PCN# 20130520005
Qualification of CLARK-AT as new assembly site
for affected device(s) moving from SCSAT, corresponding package change from
punched RTK to sawn RGP and change of orderable part number(s)
Change Notification / Sample Request

| PCN Number: | 20130520005 | PCN Date: | 06/19/2013 |
| Title: | Qualification of CLARK-AT as new assembly site for affected device(s) moving from SCSAT, corresponding package change from punched RTK to sawn RGP and change of orderable part number(s) | | |

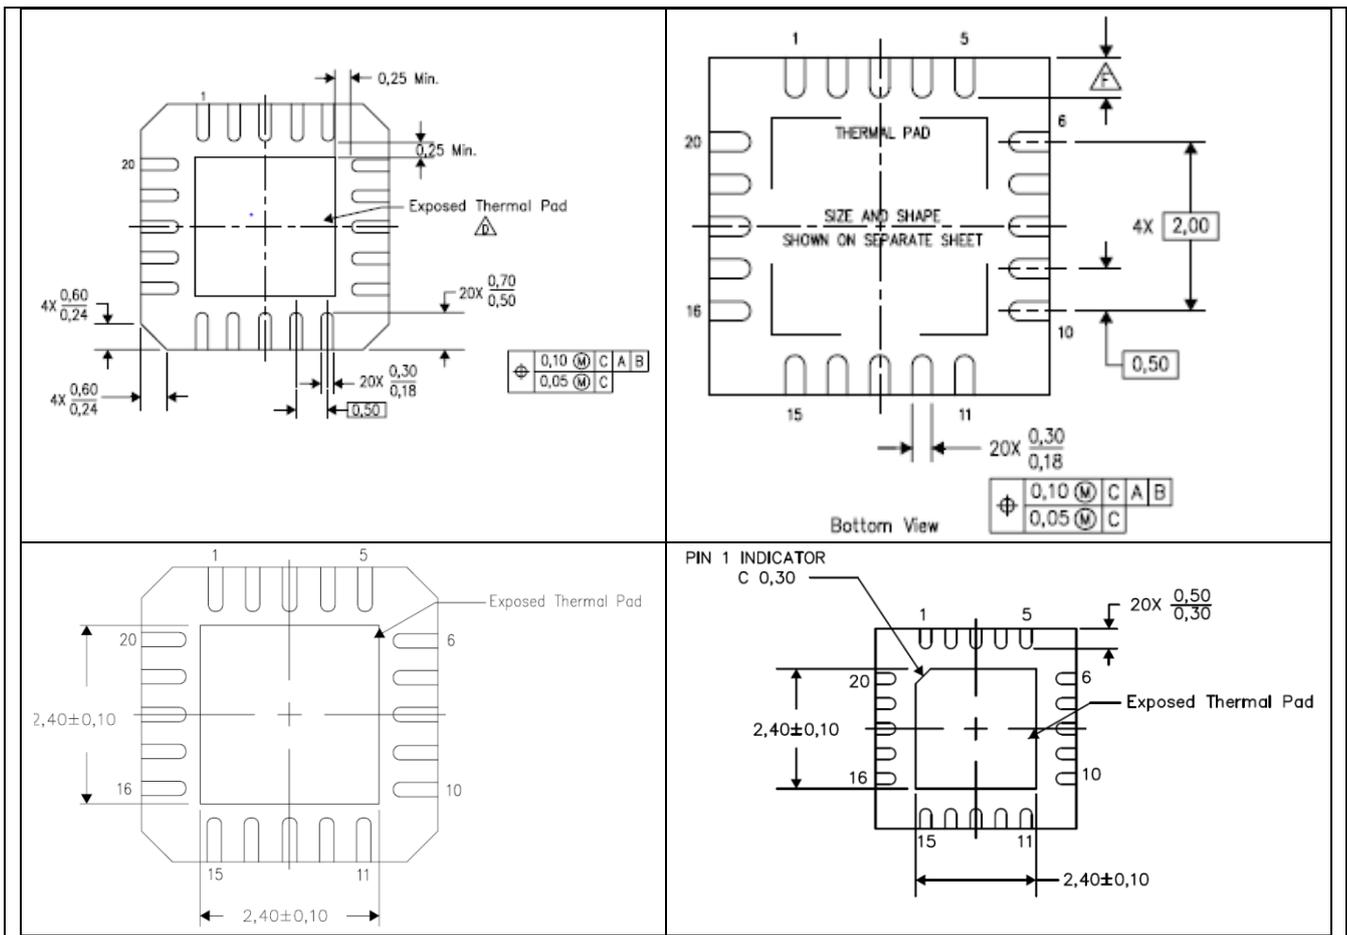
| <p>Texas Instruments is pleased to announce the ongoing qualification of its CLARK-AT facility as a new assembly site for 4x4 mm, 20-pin RTK VQFN packaged device(s) currently being assembled at its SCSAT subcon facility. A package change (see package mechanical drawings) and an order number change will accompany this change. The sawn RGP package is considered backwards compatible with the punched RTK package, i.e. no PCB footprint change is necessary. Please see the tables below for further details on site and associated RoHS compliant and REACH compliant bill of material changes. Packing materials (shipping boxes, tape & reels, tubes, etc.) at the additional site will be consistent with materials currently in use at that added site.</p> | | | |
| | Current | Qualification | |
| Assembly Site | SCSAT | CLARK-AT | |
| Package Designator | RTK | RGP | |
| Leadframe | SID#R002-2077X (NiPdAu) | 4211288-0003 (NiPdAu) | |
| Mount Compound | SID#R008-0103X | 4207123-0002 | |
| Mold Compound | SID#R003-0302X | 4208625-0005 | |
| Bond Wire | SID#R005-0077X 25.4 µm (1 mil Au) | 4072459-0500 (0.96 mil Au) | |
